## Application for Works Approval

<b>Works Approval Number</b>	W3086/2025/1
<b>Applicant</b>	City of Greater Geraldton
<b>Application number</b>	APP-0030173
<b>Premises</b>	Meru Waste Disposal Facility Landfill Road NARNGULU WA 6532  Legal description - Lot 203 on Plan 403161;  Lot 204 on Plan 403161; and Part of Lot 2268 on Plan 250829  As defined by the premises map attached to the issued works approval and by the coordinates in Schedule 3 of the works approval
<b>Date of report</b>	17 December 2025
<b>Decision</b>	Works approval granted

**Figure 1: Typical basal lining system**

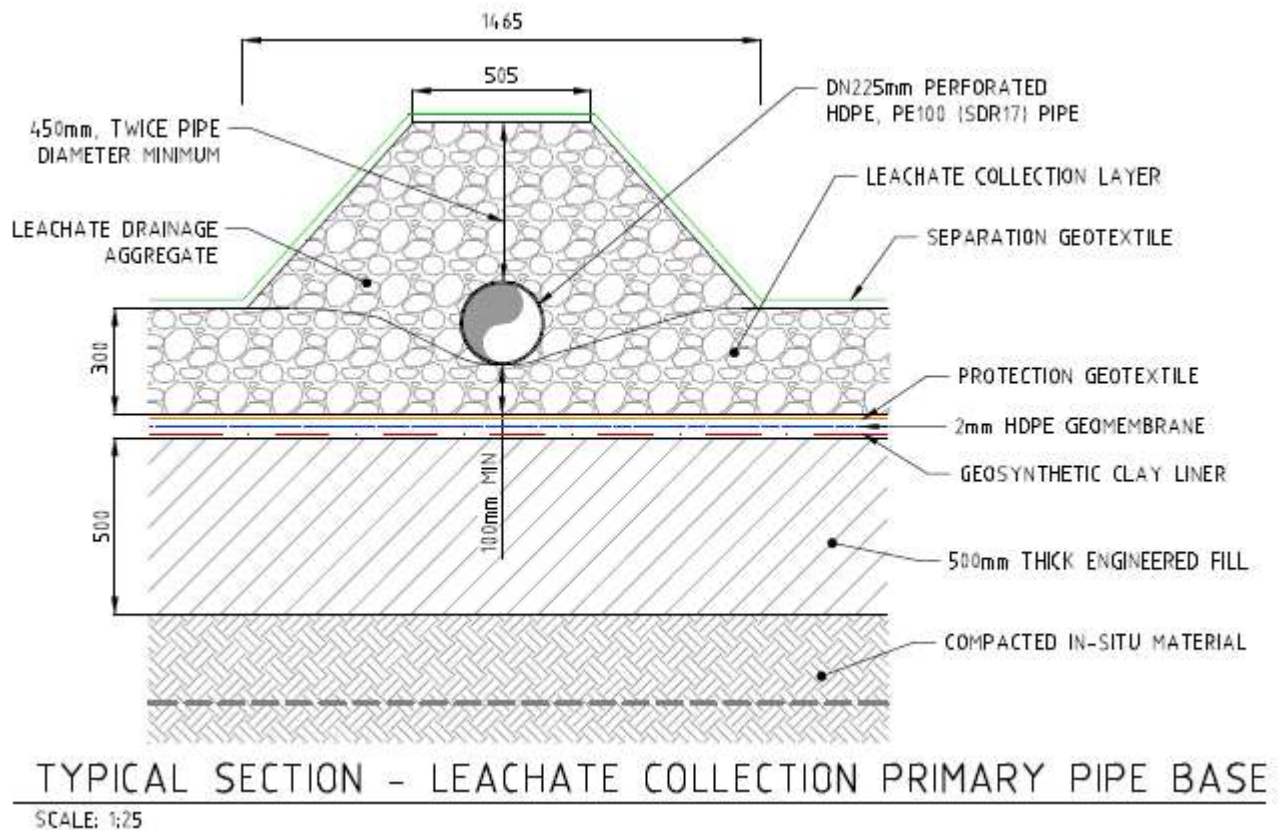
The northern boundary of cell 6 will tie into the southern side of the still active cell 5 at the existing intercell bund. The cell 6 class III landfill comprises of an engineered composite lining system consisting of the following elements (in order of installation):

1. The design specifications of cell 6 are consistent with the specifications expected for Class III landfill cells. The suitability of the construction in the context of the premises location will be considered in the risk assessment.
2. A leachate balance assessment found that the premises infrastructure is able to manage its leachate within the existing leachate pond over the modelled 5-year worst-case period without the leachate pond overtopping.
3. The landfill stability report indicates a number of factors of safety cannot be achieved for the proposed capping system and that the works approval holder should give consideration to the recommendations of Talis Consultants.

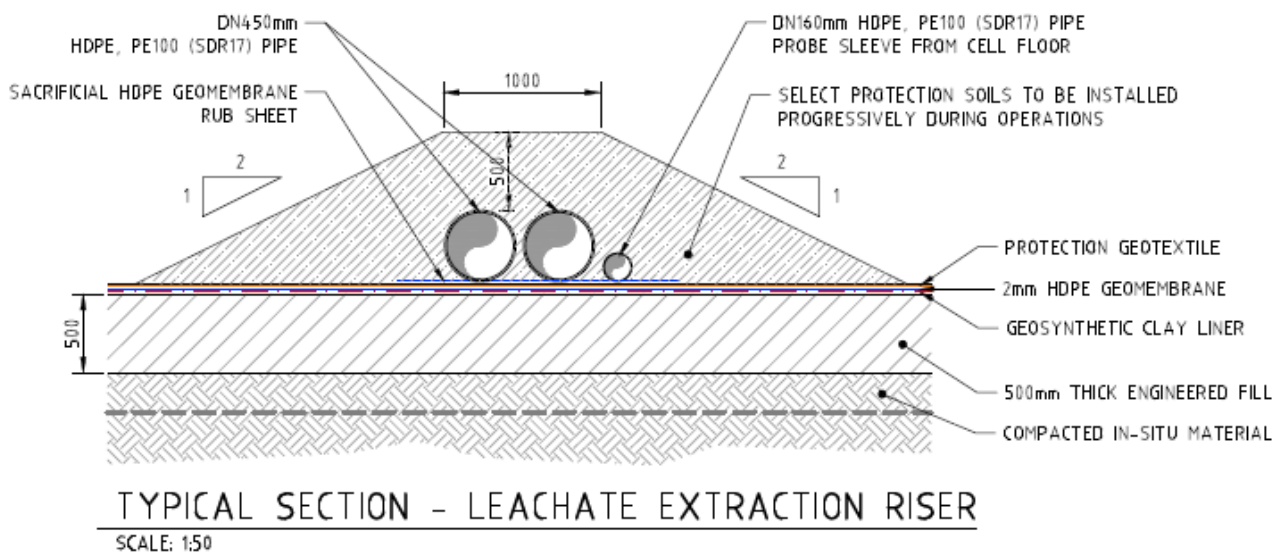
The pipe network consists of a DN160 HDPE perforated secondary pipes at maximum 25m spacings connected to a DN225 HDPE perforated primary pipe to direct leachate to the cell 6 sump for extraction. The base of the cell has been designed with 3% cross falls to the primary spine drains with minimum 1% falls orientated diagonally across the cell base to direct leachate towards the collection sump located in cell 6.
